Planning and Highways Delegations Committee

This report deals with an opportunity to submit representations to the Planning Inspectorate on a proposal by Highways England to dual the A47 between North Tuddenham and Easton. The proposal is deemed to be a Nationally Significant Infrastructure Project (NSIP). Highways England's application for development consent will be determined by the Secretary of State.

- 1.1. This is a Development Consent Order (DCO) application for dualling part of the A47 between North Tuddenham and Easton, which will be determined by the Secretary of State. The application is defined as a Nationally Significant Infrastructure Project (NSIP) under the Planning Act 2008.

Appendix B: Wood Lane Junction showing connection to Norwich Western Link (in pink)

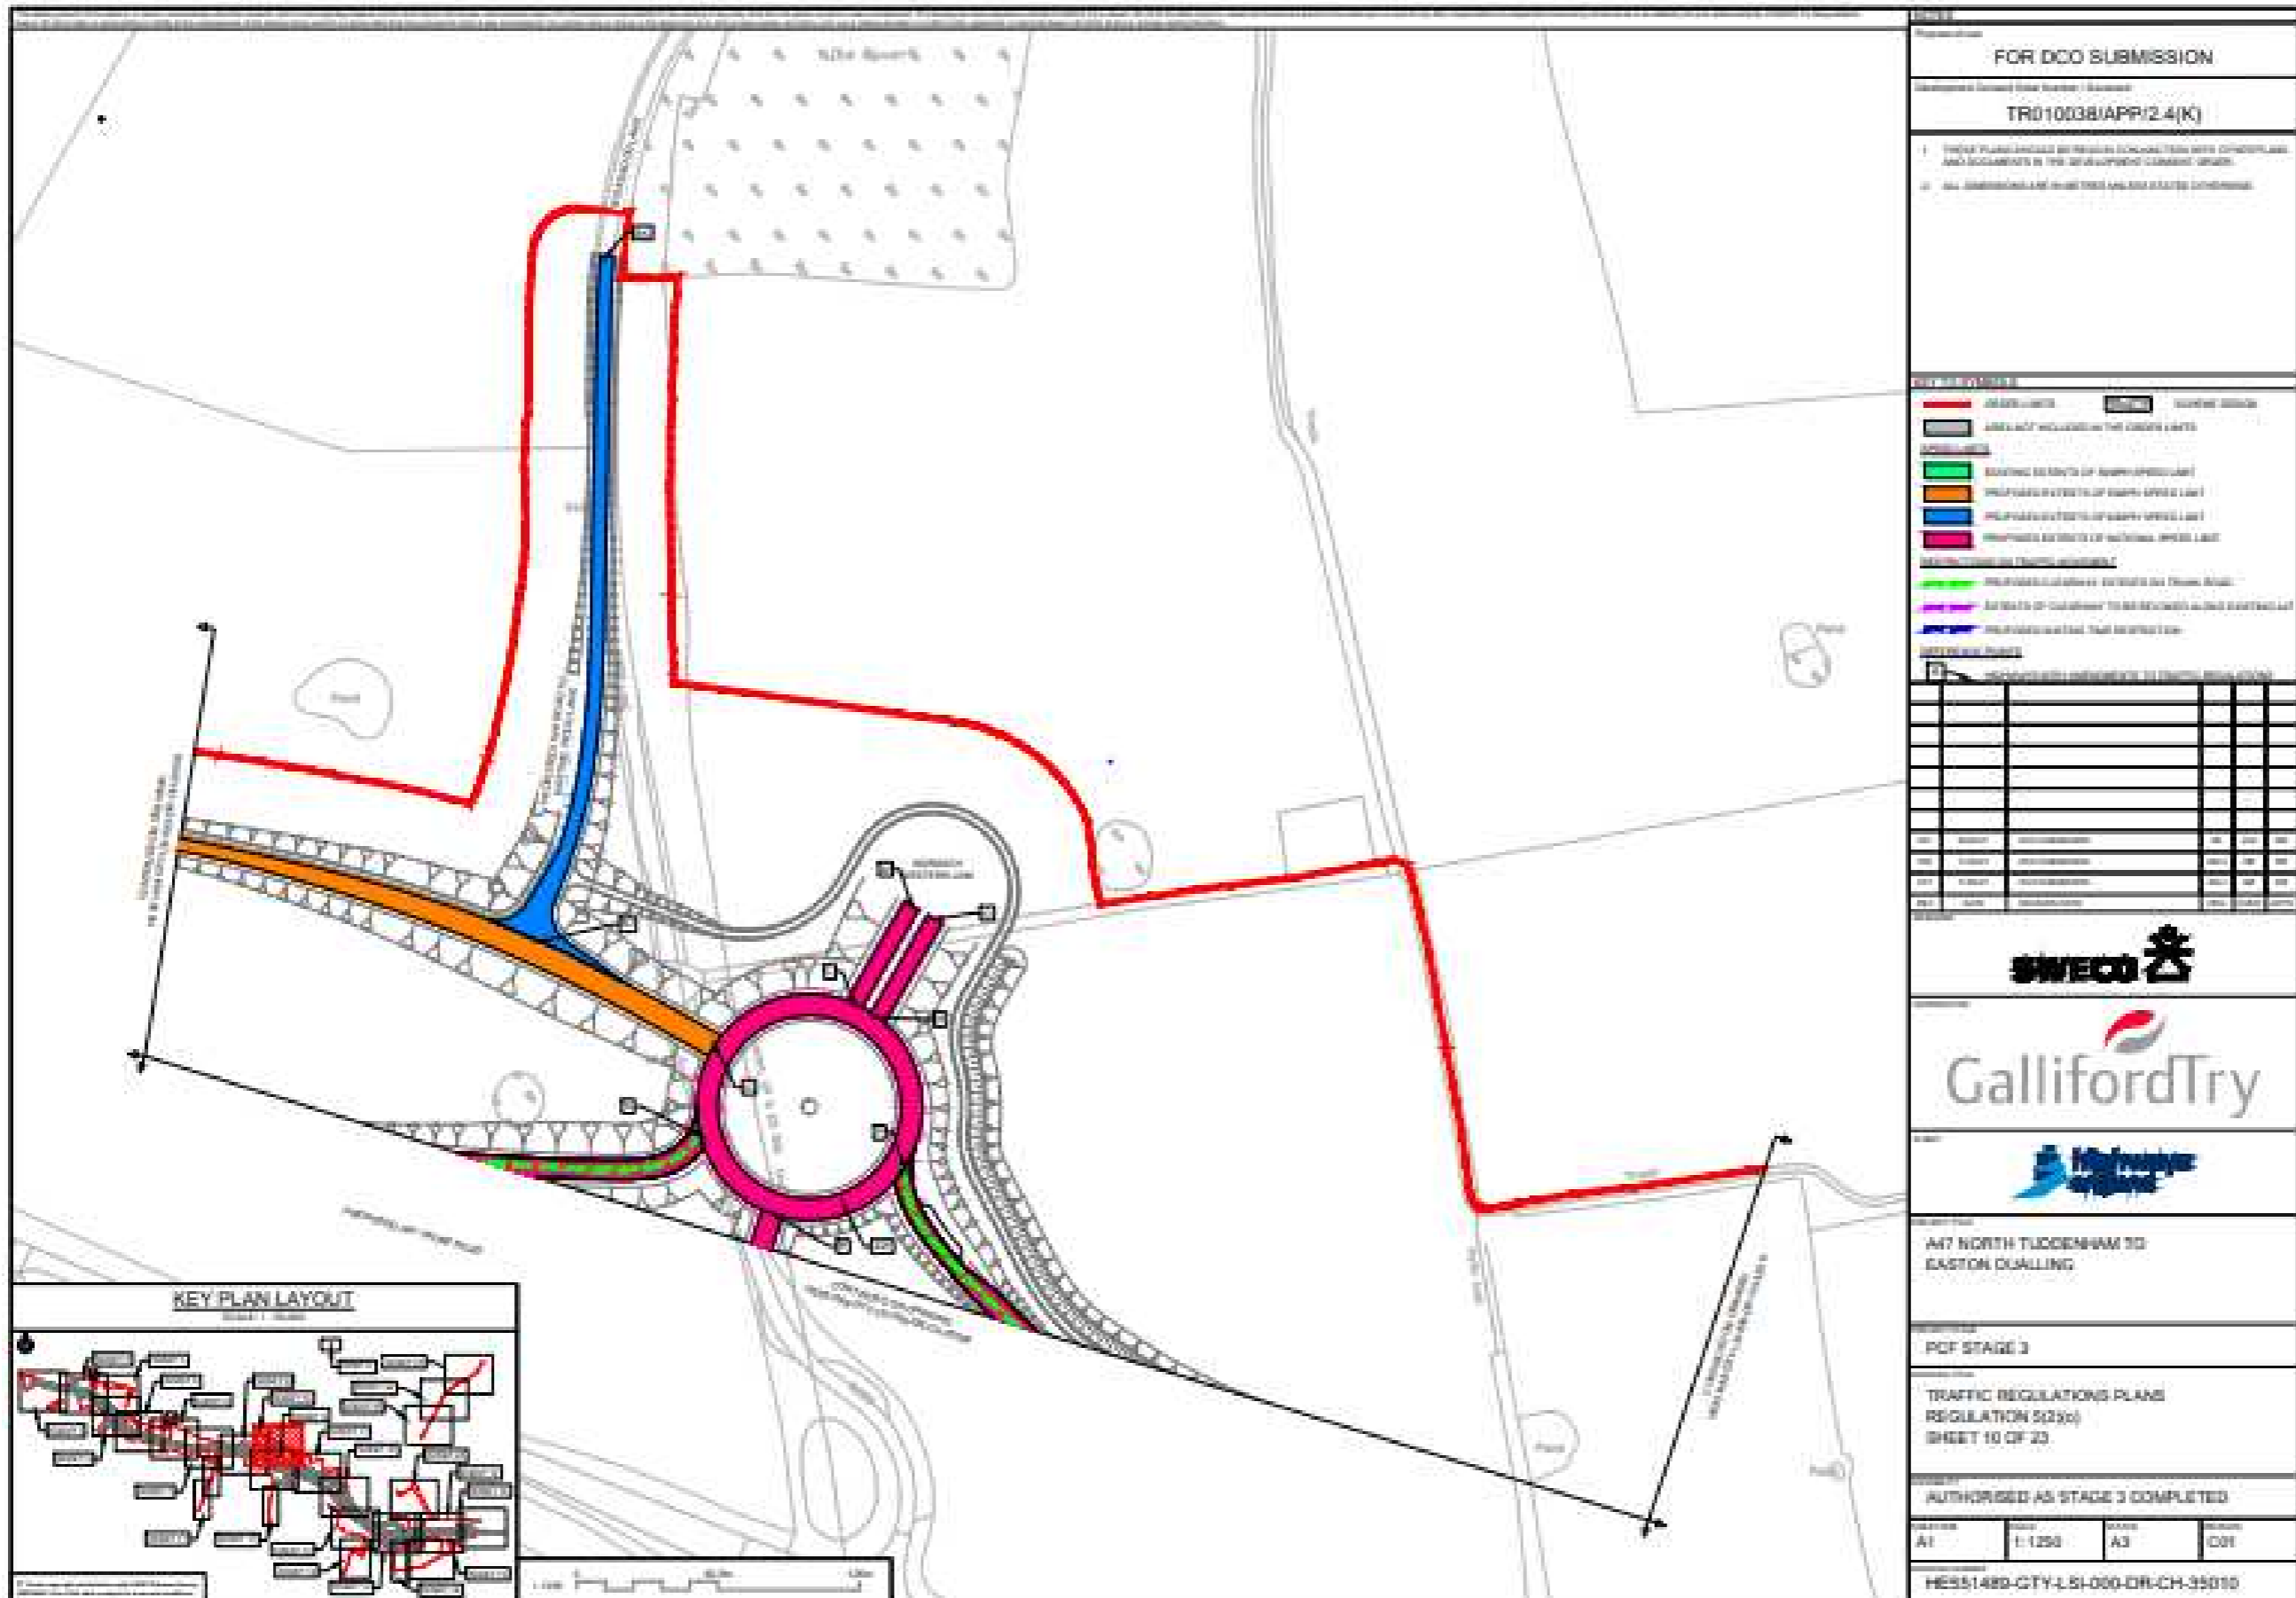
The A47 scheme includes a proposed cycle track between the realigned Wood Lane and Hall Farm Underpass. This is shown as looping round the NWL arm of the Wood Lane junction. In discussions with Highways England, Norfolk County Council understands that this is a temporary arrangement and, on completion of the NWL, will be superseded by the permanent facilities being planned as part of the NWL scheme.

However, we have concern that local users will not appreciate the temporary nature of Highways England's proposals in this area and would expect Norfolk County Council to provide a crossing of the NWL at the proposed A47 Wood Lane junction. This is not supported by the county council.

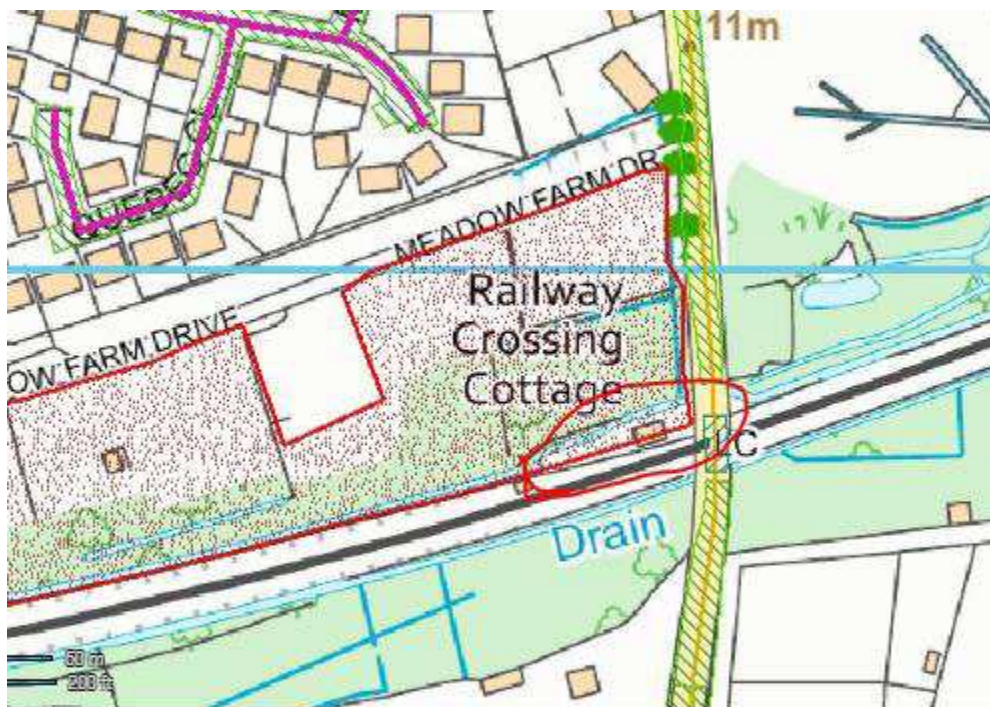
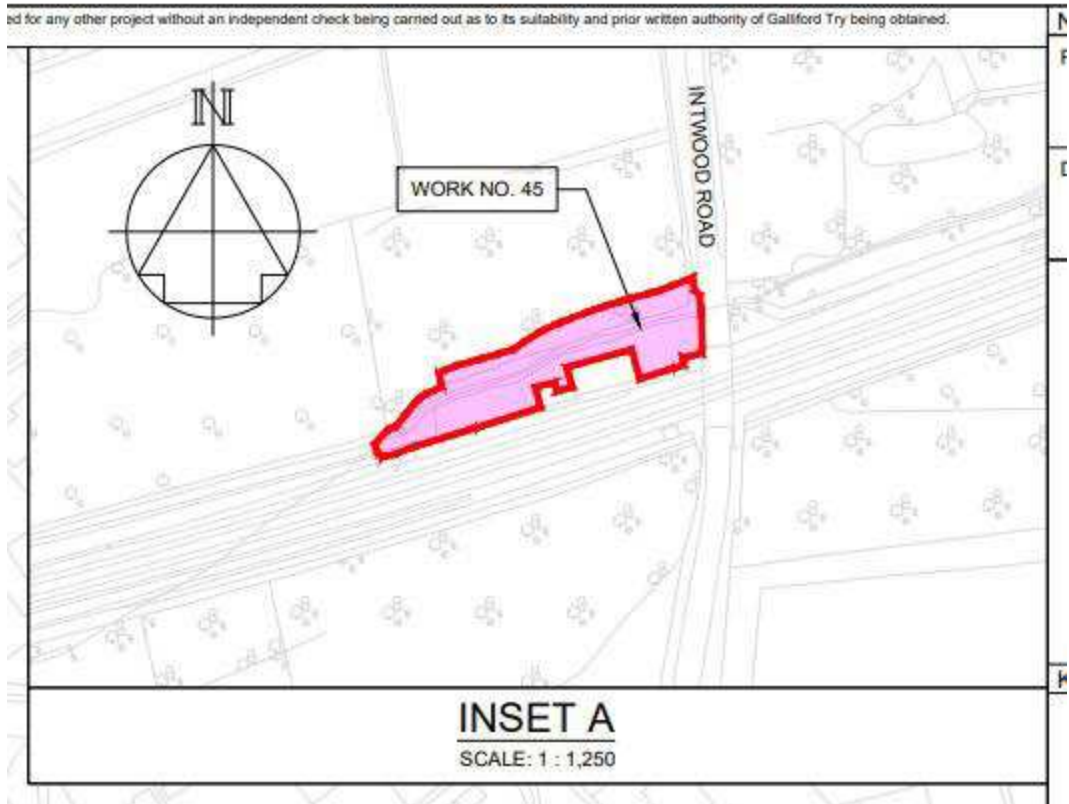
- As alluded to within the bat report, Cantley Lane is an important commuting and foraging corridor for bats. Surveys undertaken in support of 2017/2120 9south Norfolk Council) show that it is of high value to bats (see below). See below: (taken from 2020/0499).

- The loss of substantial areas of vegetation on both sides of the A47, along the line of Cantley Lane, as well as that along the A47 to the south, shown on drawing no. 1050831-SWETHI-AIAP (in the Arboricultural

Impact Assessment), will likely result in the loss of this commuting route across the road (a circa 170m gap), and/or increased risk of collision (no evidence has been provided to suggest that the proposed mitigation will be effective. Vegetation also provides bats with shelter from wind and protection from predators. The vegetation also provides a buffer for road noise and head lights.

Figure 2b

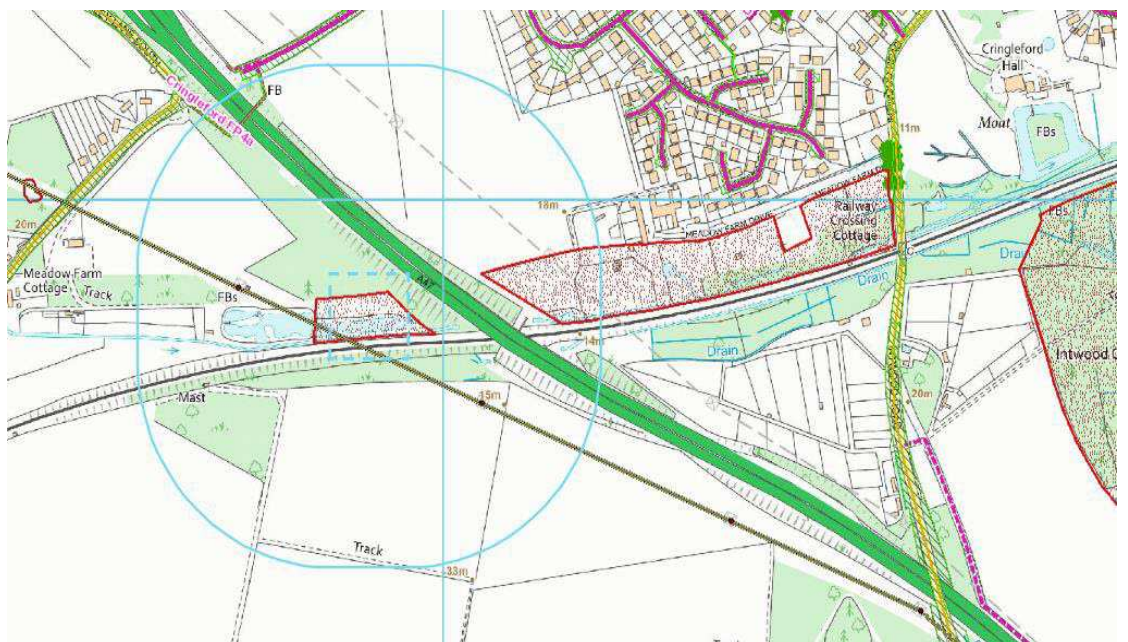
- Para 7.6 also notes ‘The southern edge of Area N, a priority habitat and potentially ancient woodland (present since at least 1840) will be impacted by a new road. This will be an intermediate impact on this feature. Mitigation is advised’ the potential presence of ancient woodland is not mentioned elsewhere and Chapter 8 only refers to veteran trees on the ancient woodland inventory (para 8.7.14)
- It should be established if this woodland is ancient and the scheme re-designed to avoid this area as recommended in section 8 of the botanical report. It is noted that this is not reflected in para 6.1 which assigns area N as of local value only.
